**Class II change apply for WLP020**(From WLP020 FCC ID: H8N-WLP020)

**WLP020 CLASS II CHANGE**

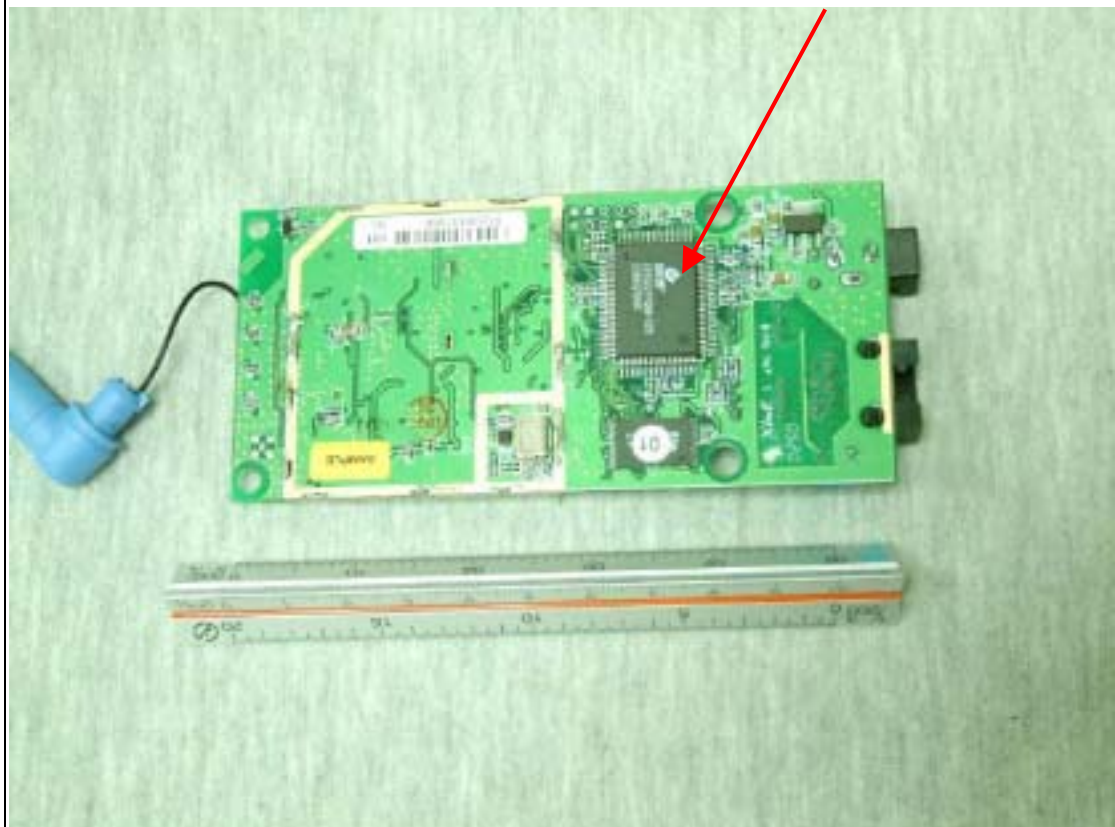
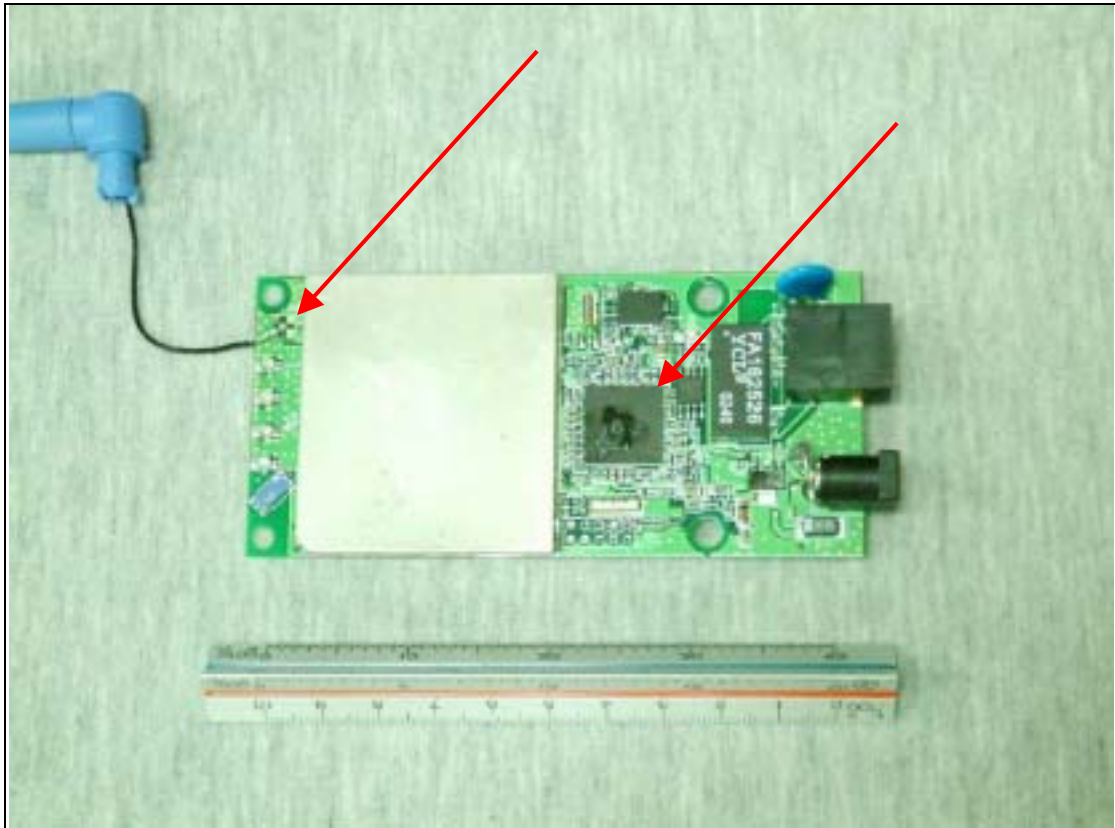
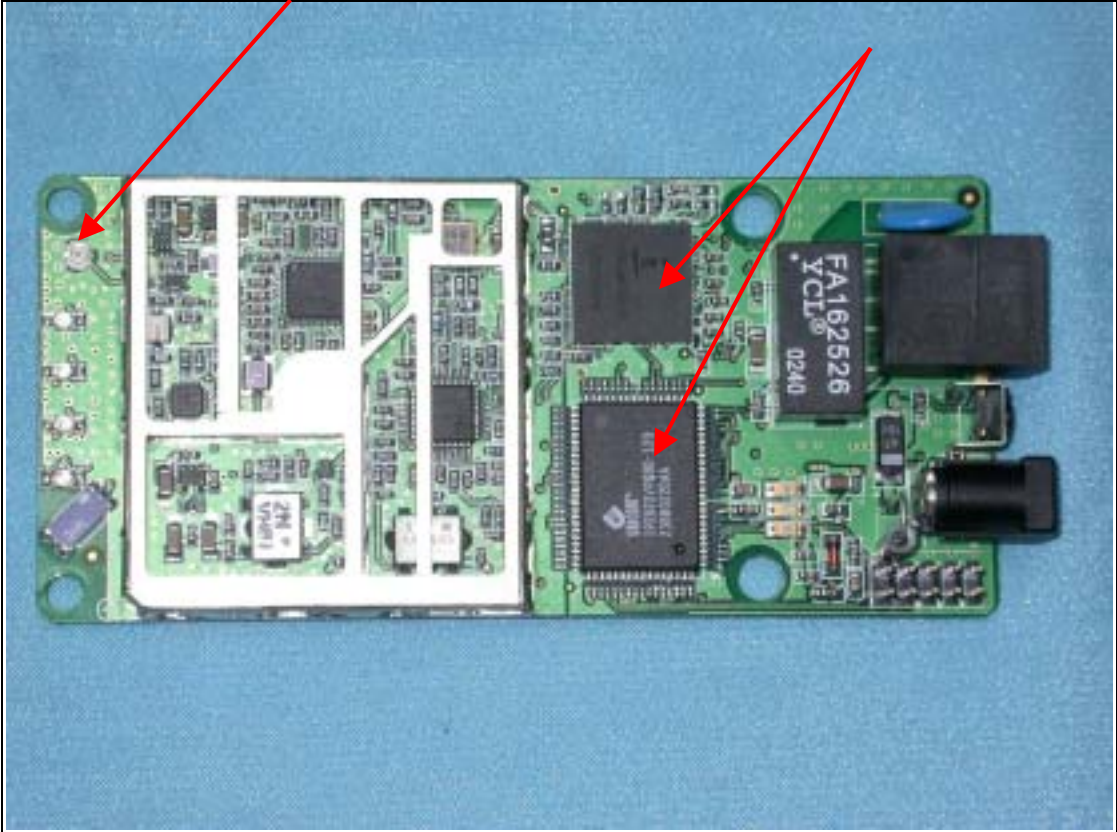
Modified1: the layout from the Baseband IC , Ethernet IC each side top and bottom layer to them are same as side on top layer.

Modified2: the antenna pad of MMCX to Hirose pad.
